Proposal for the 01 Series of Amendments to UN Regulation No. 145 (ISOFIX anchorage systems, ISOFIX top tether anchorages and i-Size) *

Submitted by the expert from the Netherlands

The text reproduced below was prepared by the Ad Hoc Group on Child Restraint Systems, aiming to introduce definitions, requirements and a test procedure for lower tether anchorages. The modifications to the existing text of the UN Regulation by document ECE/TRANS/WP.29/GRSP/2023/12 are marked in “bold black“ for new or strikethrough for deleted characters. The modifications made by this document are marked in “**(bold) blue**” for new or strikethrough for deleted characters.

Figure 1
Lower Tether Anchorage Zone: Side View
 (Dimensions in millimetres)

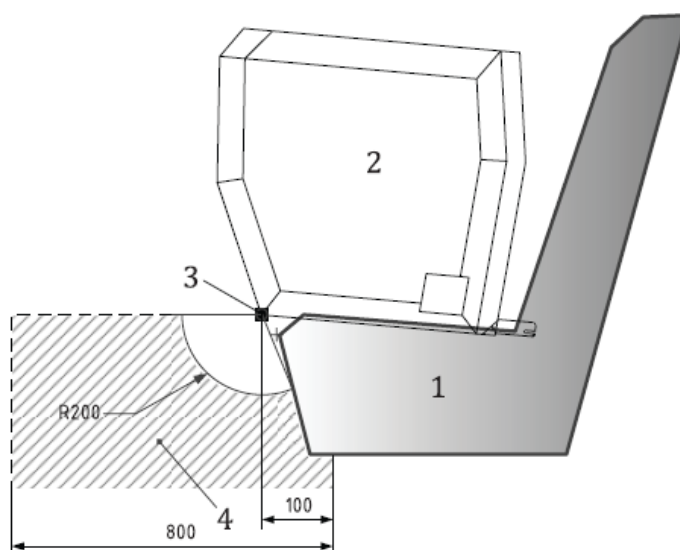
- Key:**
1. vehicle seat illustration.
 2. ISO/R2 envelope installed in related vehicle seating position.
 3. reference point on ISO/R2 envelope for LTA zone measurements.
 4. lower tether anchorage zone in side view, with upper limitation.
 5. where the LTA is integrated with the seat in front, the zone requirements have to be fulfilled independent of the height adjustment settings of the seat in front, **taking the presence of the ISO/R2 envelope into consideration.**
